Attachment 7-12 Addendum to the Sunbury network
development strategy

Sunbury - Diggers Rest Growth Corridor

Network Development Strategy (Addendum)

ELE PL 0030 (A)

Figure 1–1: Existing Sunbury Zone Substation (SBY) Single Line Diagram

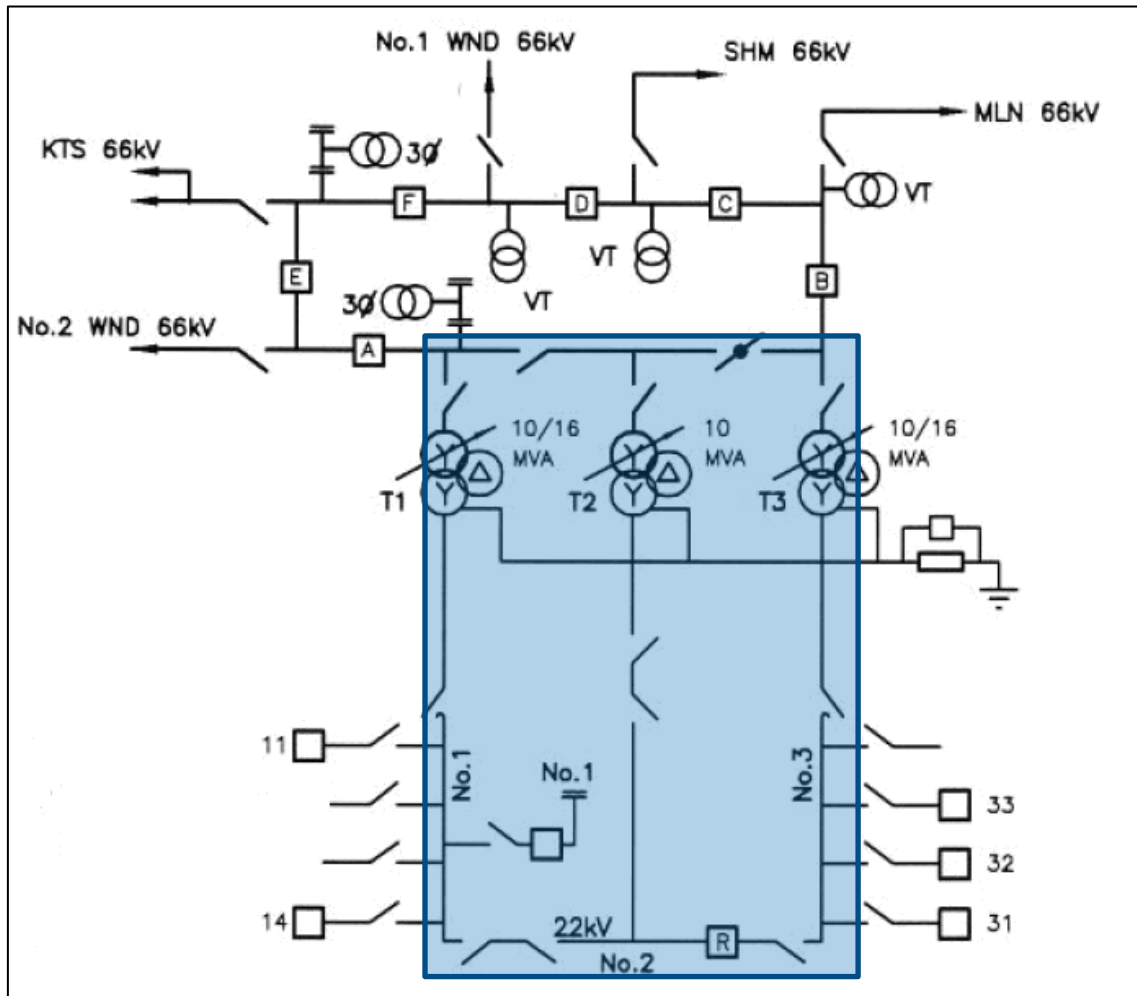
1. **Reliability will not be maintained:** Currently all three transformers are in a single switching zone, meaning there are no 66kV and 22kV circuit breakers (CBs) to isolate fault zones. Any fault within the station will result in a supply interruption to all customers supplied from SBY. There have been 17 times in past 20 years when all customer load at the substation has been lost due to faults within the station. For the standard switching arrangement, typical at other JEN substations, single contingency events do
